Stellar La Mesa Subdivision Unit Two

City Plan Commission — June 5, 2025 **(REVISED)**

CASE NUMBER/TYPE:	SUSU25-00006 – Major Combination
CASE MANAGER:	Alex Alejandre, (915) 212-1642, AlejandreAX@elpasotexas.gov
PROPERTY OWNER:	Coronado Holdings, LP
REPRESENTATIVE:	Brock and Bustillos, Inc.
LOCATION:	West of Interstate I-10 and North of Woodrow Bean Transmountain Rd. (District 1)
PROPERTY AREA:	11.68 acres
VESTED RIGHTS STATUS:	Not Vested
PARK FEES:	Pending Restrictive Covenants
EXCEPTIONS/MODIFICATIONS:	Yes, see following section
ZONING DISTRICT(S):	R-3 (Residential)

REQUIRED CROSS-SECTION:

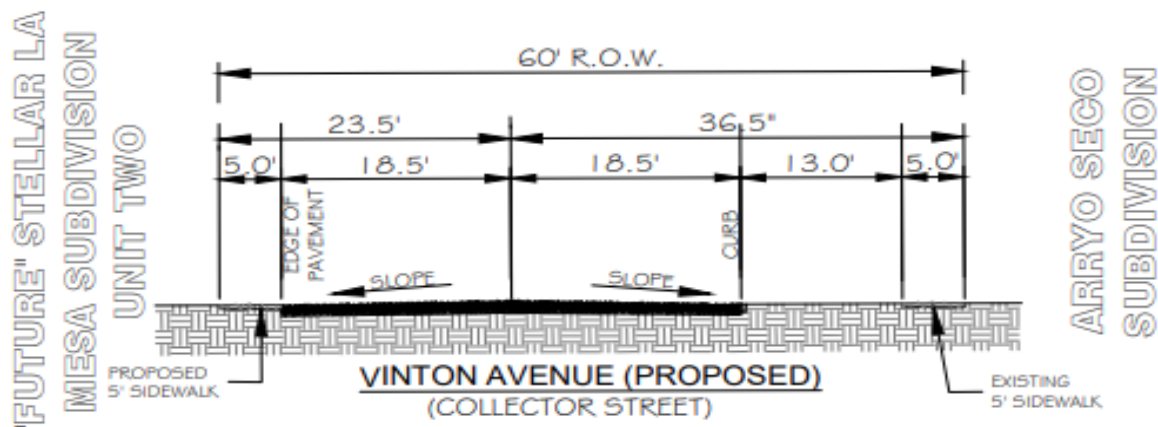
- To waive the dedication of (5.5') feet of additional right-of-way, the construction of (7') feet of additional roadway, the construction of (5') feet of planter strip, and to allow the sidewalk to abut the roadway along Vinton Avenue.

EVALUATION OF EXCEPTION REQUEST: The exception requests to waive right-of-way improvements meets the following criteria under El Paso City Code 19.10.050(A)(1)(a) – (Roadway Participation Policies – Improvement of Roads and Utilities Within and or Abutting the Subdivision). The section reads as follows:

Figure B: Developed properties within a quarter mile of proposed subdivision

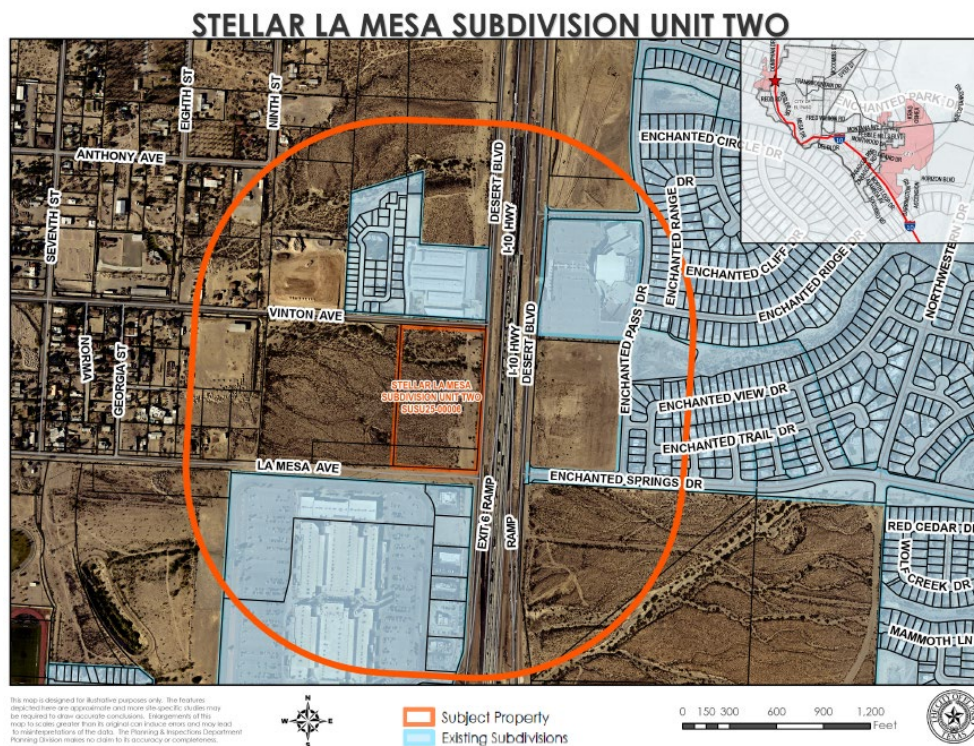
a: Fifty per cent of the lots within a quarter mile of the proposed development have already been developed and the existing street improvements are in character with the neighborhood.

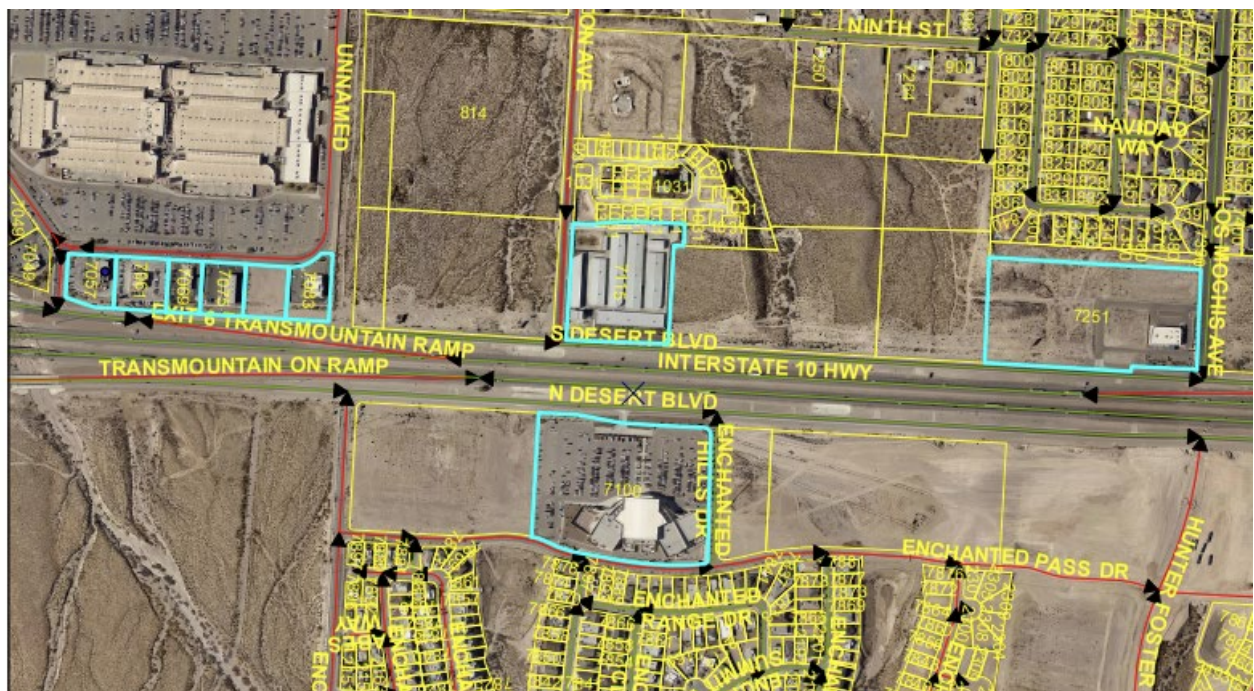
Regarding the proposed address of 7901 S Desert Blvd, please note that this is out of range with the existing addressing surrounding this property. Attached is a screenshot showing the surrounding addresses. I recommend an address of 7101 S Desert Blvd instead of 7901.
